CHANGES FROM BASE PRODUCT BE-PX1015 (3006) TO AC-062 (4691)

Assembly PI Approval S.ATTWOOD 13/03/14		Approved by G.PLITH		Checked by R.BATES		Drawn by P.MISSEN	
Angle of Projection 		Units mm	Scale N/A	Released 01/04/14		Assembly Ref -	
Third Angle		Status RELEASED		AC-062			
		Part No 4691		BE-002856-00-14

VIEW A-A
CABLE BUILDUP

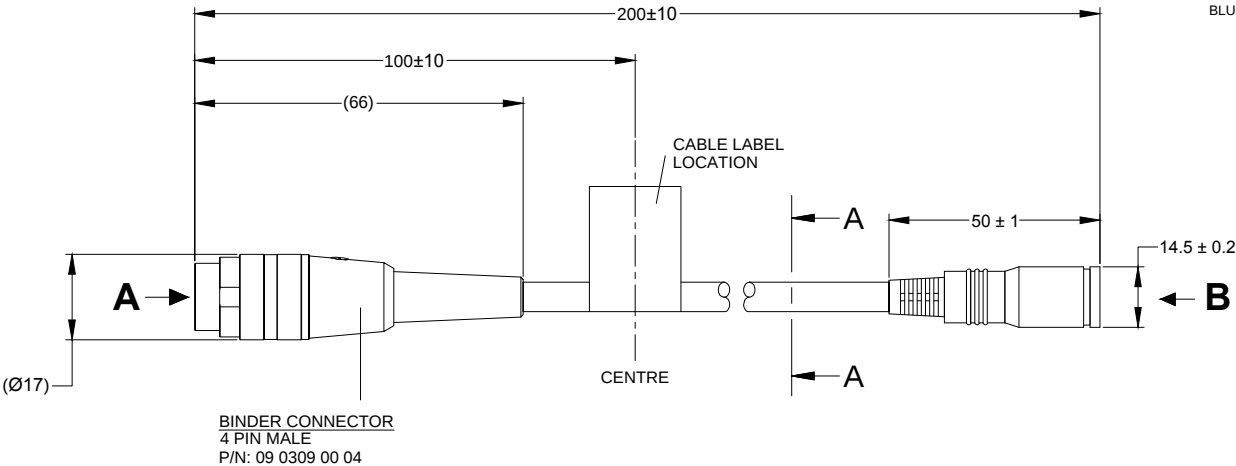
- CHANGE:
- CUT CABLE TO REQUIRED LENGTH.
 - REPLACE MALE CONNECTOR WITH 4 PIN MALE BINDER CONNECTOR.
 - REPLACE GENERIC CABLE LABEL WITH AC-062 CB-LBL.
 - REPLACE GENERIC GIFT BOX LABEL WITH AC-062 GB-LBL.
